### 4054/4054A SCREWS CPU SANDWICH TO FRAME ASSEMBLY

Ref: 4054/4054A Parts and Schematics  
Service Manual, Part Number  
070-2839-03

W2 Issue 13-23

Figure 1

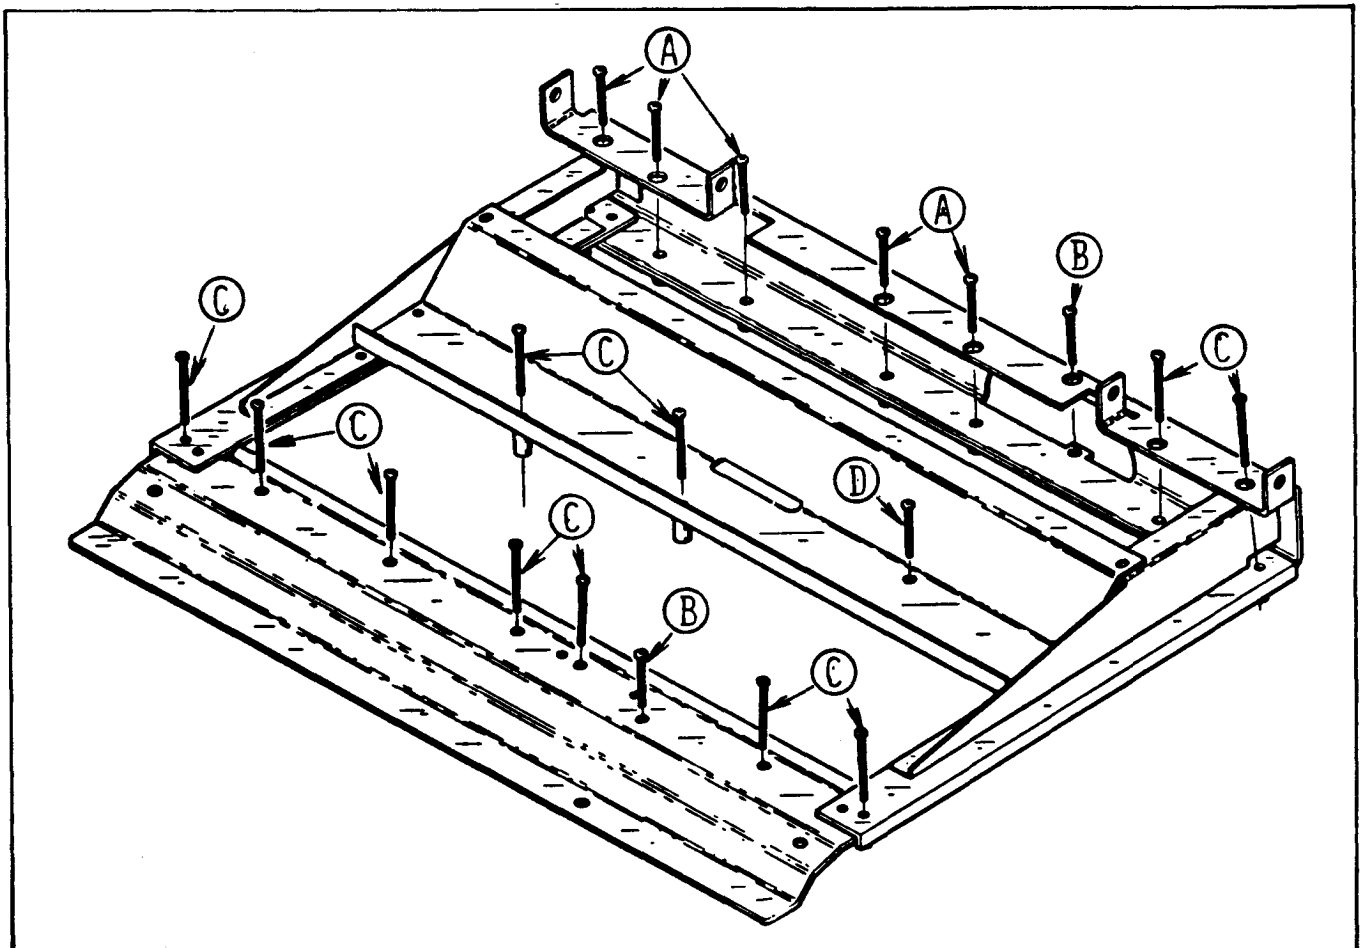
Questions have filtered in from different field personnel concerning the length and placement of the screws which hold the CPU sandwich to its frame assembly. The figure below shows the frame assembly, the screws and the holes which the screws are inserted through. Note circled alpha characters, each denote a different length screw. Following the figure is a table for cross-referencing the index character to screw length.

Note that there are two "D" type screws listed. On the 4054A this screw goes through the ALU board and into the I/O board, whereas on the 4054 it only screws to the ALU board.
